**Project #21-065
Zeppe's Italian Ice & Custard
Located at 811 North Main Street**

REPORT SUMMARY...

Project Name: Zeppe's Italian Ice and Custard
Proponent/Owner: Todd Coleman / Dick Sackett
Project Address: 811 North Main Street
Request: Design Review Permit
Current Zoning: Commercial (COM)
Date of Hearing: Nov. 18th 2021
Type of Action: Quasi-Judicial
Submitted By: Russ Holley, Senior Planner

Figure 1 shows the proposed East facade

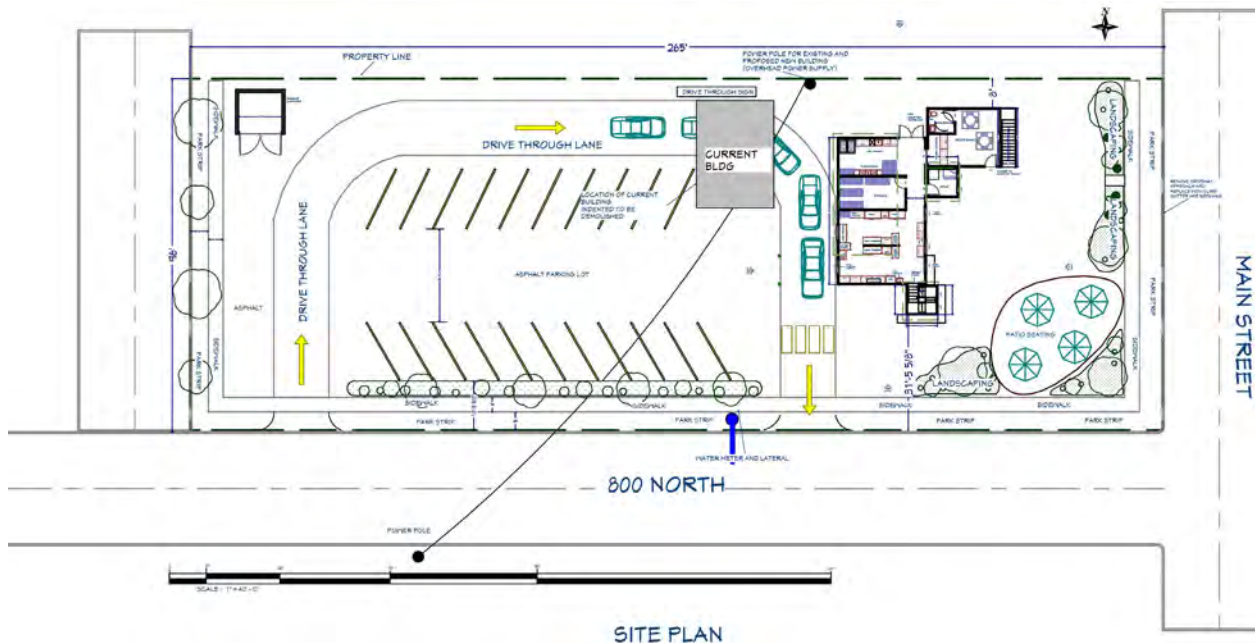
The proposed building consists of metal shipping containers welded together and stacked in unique positions. Windows are cut into the container walls and parapets, awnings, railings and other similar features have been added to the facades for visual interest and design variation. The containers are shown being painted in several colors to further differentiate the articulations. Not considering the rear setback portion of the building the front (east) façade shows 30% transparency but the south (800 N) façade does not contain the minimum amount of transparency. Other than the awnings and windows, the building material is solely metal. As conditioned with compliance to minimum transparency on the south and a mix of materials, the building design complies with the requirements in the LDC.

1. All standard conditions of approval will be recorded with the Design Review and are available in the Community Development Department.
2. The building transparency on the Main Street and 800 North façades shall be at least 30% transparency.

3. The building design shall contain at least two building materials.
4. A sidewalk connection to the patio from the street is required.
5. The parking lot setback to 800 North shall be 10 feet.

SITE PLAN

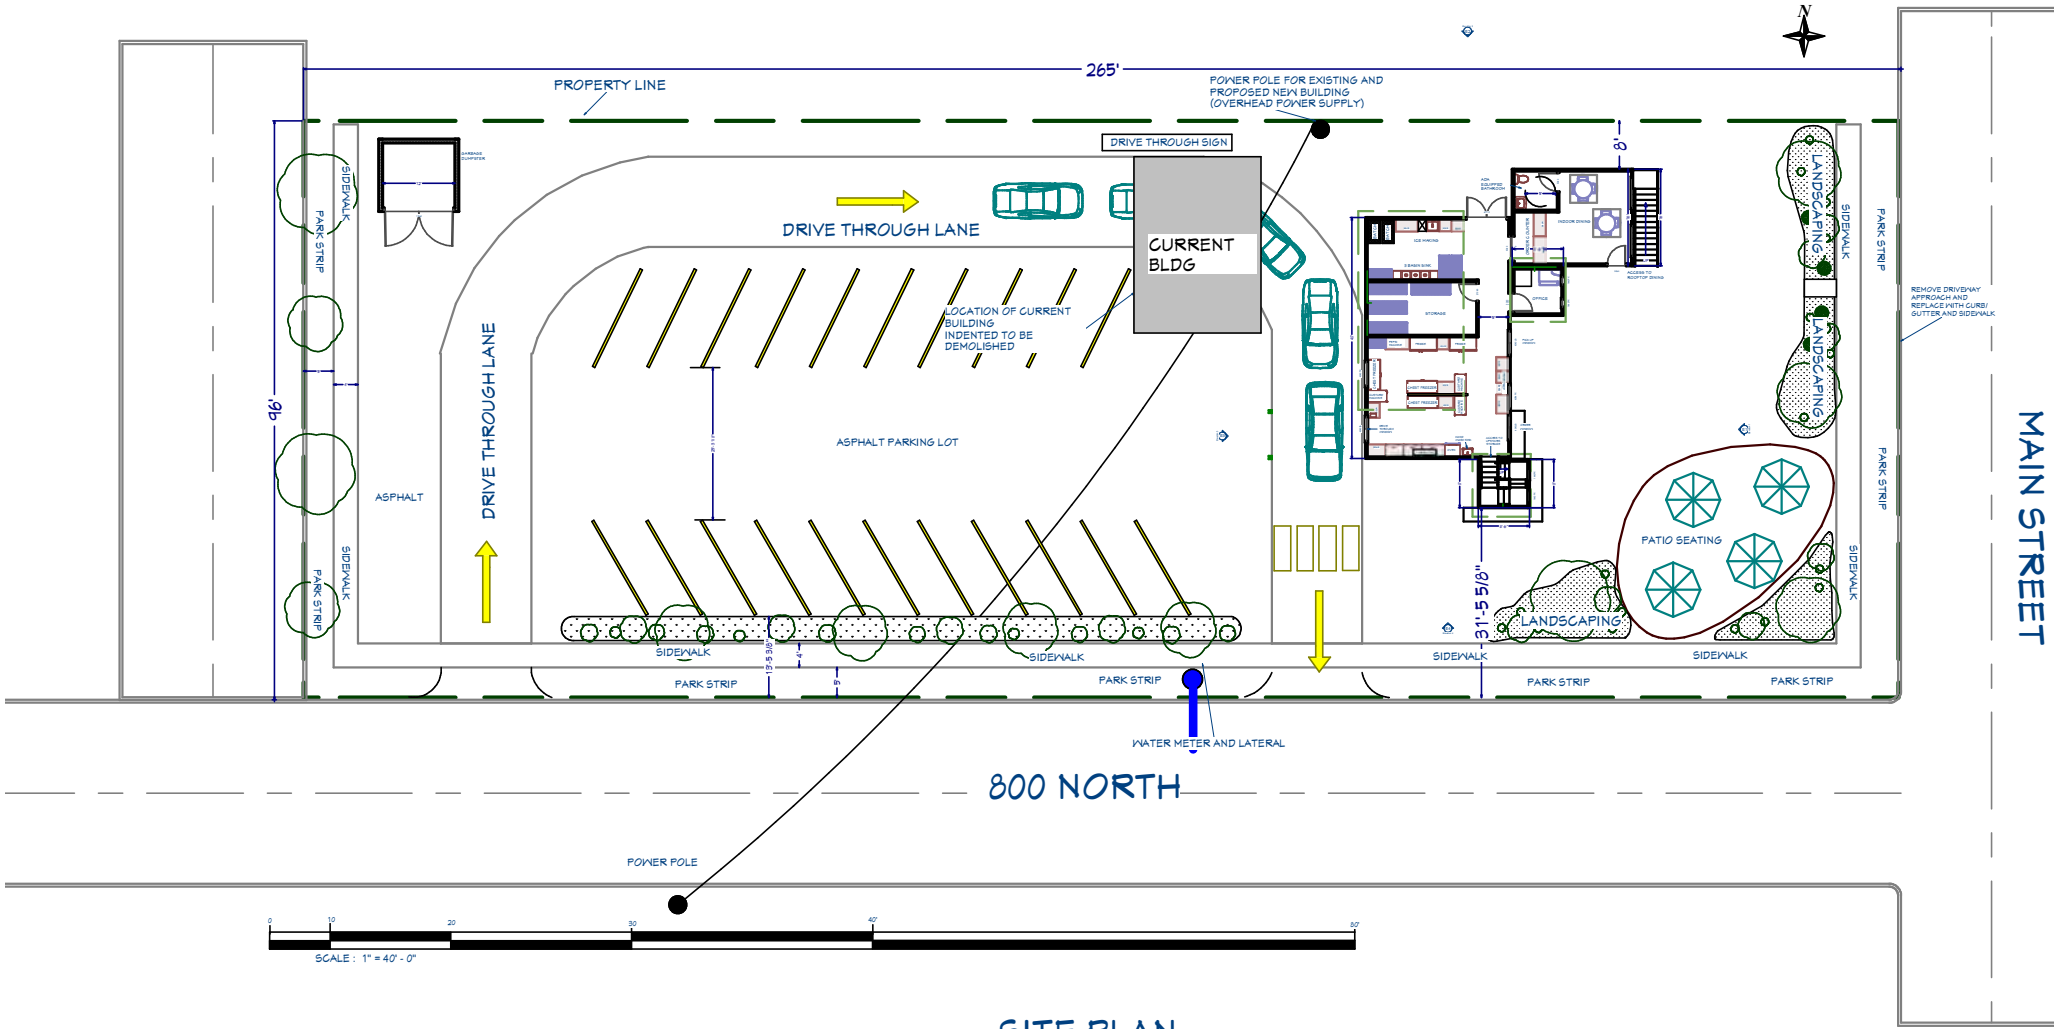
Front (East):	31'
Side (South):	23'
Side (North):	8'
Rear (West):	200'
Parking (West):	5'

As conditioned with parking setback compliance, the project meets minimum setback requirements of the LDC.

The LDC 17.10.030 requires parking lots to be placed behind or in secondary locations to the primary buildings. Pedestrian circulation should be safe and convenient that results in sidewalks connecting streets to building entrances. The site layout places the building closer to the street with the parking lot and drive-thru lane at the rear. A sidewalk connection is shown joining the building and the patio to the street. As proposed, the project meets the requirements in the LDC.

- Install all curb, gutter, park strip and sidewalk along all frontages.
- Siter plan does not show the continued use of the existing access to Main Street, coordinate with UDOT for the removal and restoration of curb, gutter and park strip in the UDOT right of way to UDOT standards.

13. Standard streetscape improvements will be required along Main Street with driveway access being limited to the joint access agreements located to the north of this site.
